**From:** Sipperly, James  
**Sent:** Tuesday, September 1, 2020 9:32 AM  
**To:** Samolis, Joseph; Kozikowski, Marek  
**Cc:** Fazzino, Joseph; 'Guy Russo'  
**Subject:** Pameacha Sanitary Sewer Project - Inland Wetland and Watercourses Delineation

DATE: September 1, 2020  
TO: Joseph Samolis, Director Planning, Conservation, and Development  
FROM: Guy P. Russo, Director of Water & Sewer Infrastructure  
Agent for the Middletown Water & Sewer Department  
RE: 2020-13  
IWWA Permit Application  
Pameacha Avenue  
Response to Staff Comments

CONSTRUCTION STAGING-PHASES 2-5  
COMBINED SEWER OVERFLOW SEPARATION PROJECT  
PAMACHA AVENUE CULVERT & WATER MAIN IMPROVEMENTS  
PROBLEM AREA NO. 12 - CONTRACT NO. 17A1

SHEET 22

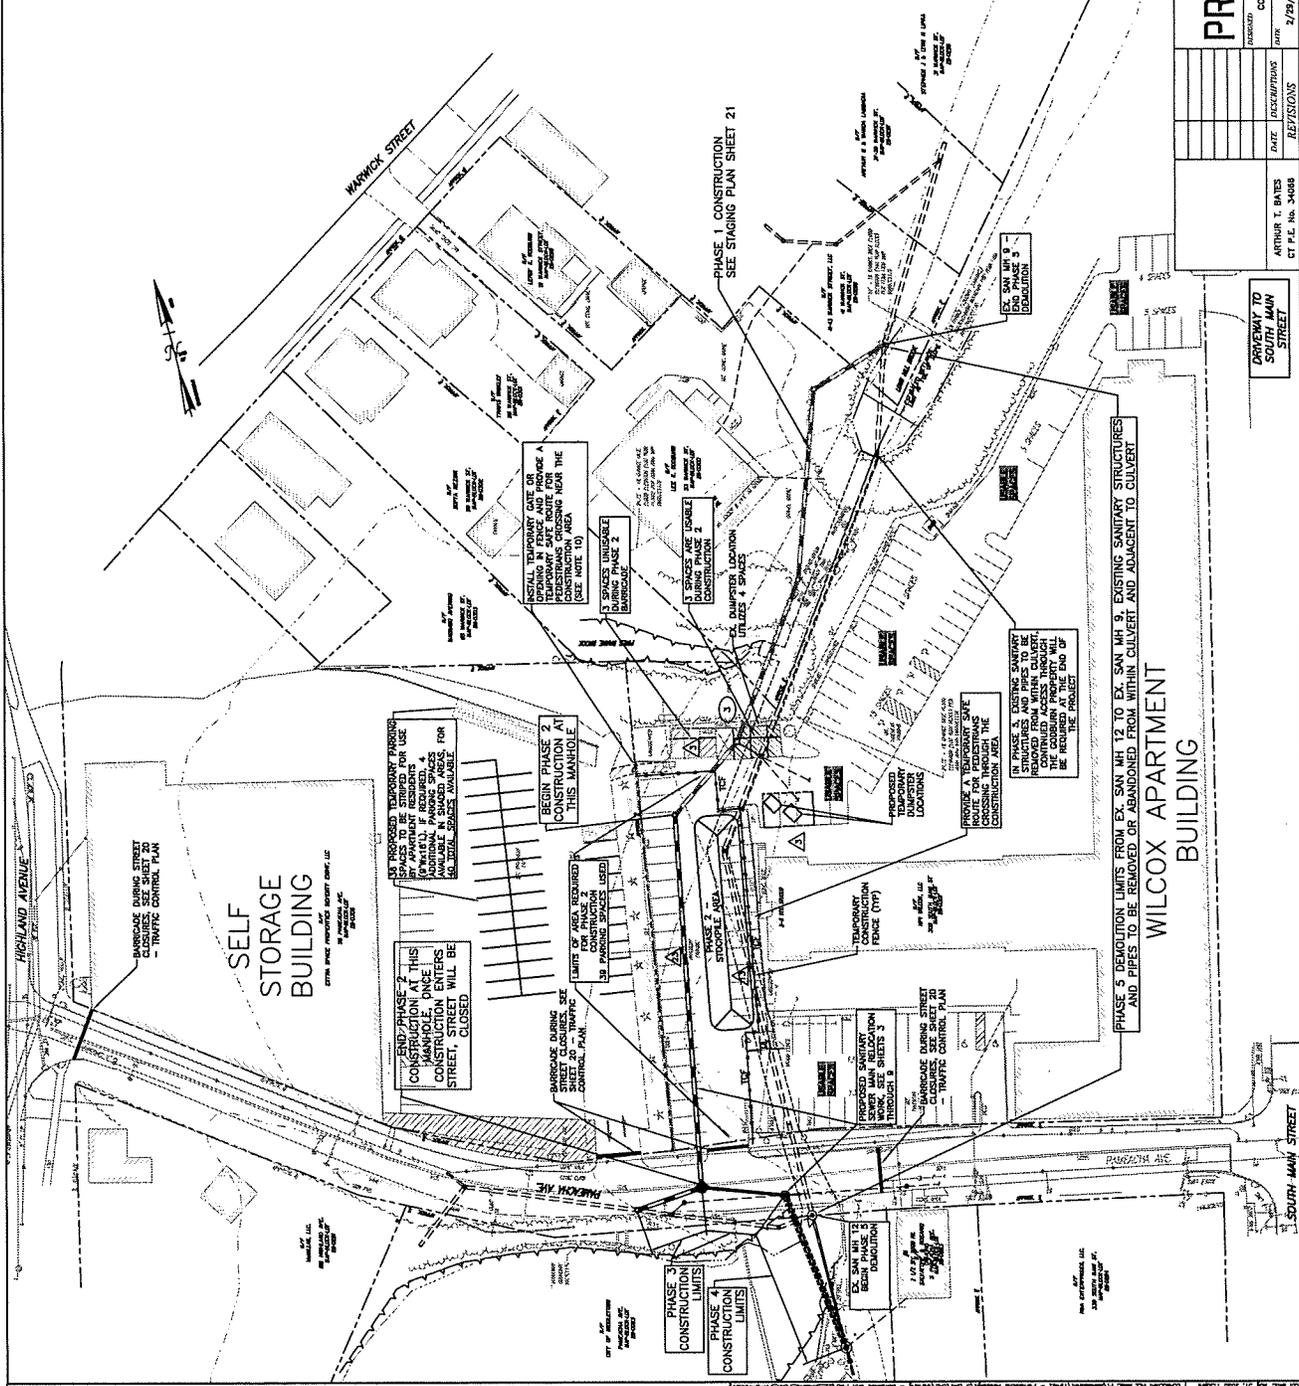
**Comment:** Stock pile and dewatering locations are not listed on the site plan. Portions of the site work are within the Flood plain, stockpile should be located outside of the flood plain.

**Comment:** Stock Pile/Dewatering locations be delineated and outside of the flood plain.

**Comment:** Note number 22 on Sheet 13 indicates stockpiling specification on Sheets 21 and 22, staff would like to review and approve prior to work commencing.

**Response:** PRIME is providing supplemental material, Sheets 21 and 22, to our original submittal. These two sheets delineate the proposed location of stockpile areas for the project. As both staff and the agency know, much of this area is within the FIRM identified Floodway. The only stockpile area not within the FIRM Floodway is the stockpile immediately east of the Godburn property, 53 Warwick Street (Sheet 22).

The project was divided in two Phases. While Sheets 21 and 22 show multiple stockpiles for Phase 1, they will be utilized when operation are within close proximity, then closed. Due to the severe terrain restriction, multiple, readily accessible storage areas were required. Phase 2 has a single stockpile area behind the Wilcox Apartments, and is depicted as containing the entire volume of Phase 2 excavated area, which will not be the case. As operations progress, in a linear fashion, the previously excavated overburden will be replaced.

**Response:** See Prior Response

**Response:** See Prior Response
